PEUGEOT/CITROËN THERMOSTAT REDESIGN TO OVERCOME OVERHEATING ISSUES

Issue Date: 23/09/19 Issue Number: COTB0025B

APPLICATION: Citroën Berlingo, C3, C4, DS3, 207, 308, 3008, 5008, Partner

APPLICABLE REFERENCES: BBT102 / BBT481

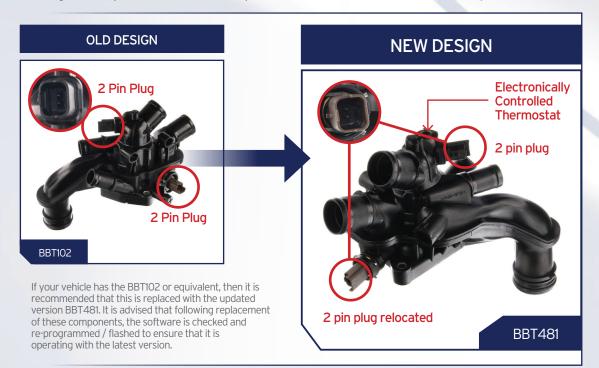
Due to an increase in overheating issues & symptoms such as an erratic temperature gauge, erratic running, radiator fan run-on, or poor heater function in the above vehicles, the O.E.M. have modified the design of the Thermostat housing. Following the O.E. specification, we have replaced the old design BBT102 with the new latest design BBT481. The latest design benefits from an electronically controlled thermostat, a reinforced structure, and a new configuration of sensors.

We have highlighted the key differences below so that you are clear that the latest part; although visually different to what may be on the vehicle, is in fact the correct product.

The modified version has had the lower 2 Pin connector relocated, therefore, a new cable may also be required to carry out the modification.

New Cable: BTS3091 - Thermostat Wiring Harness
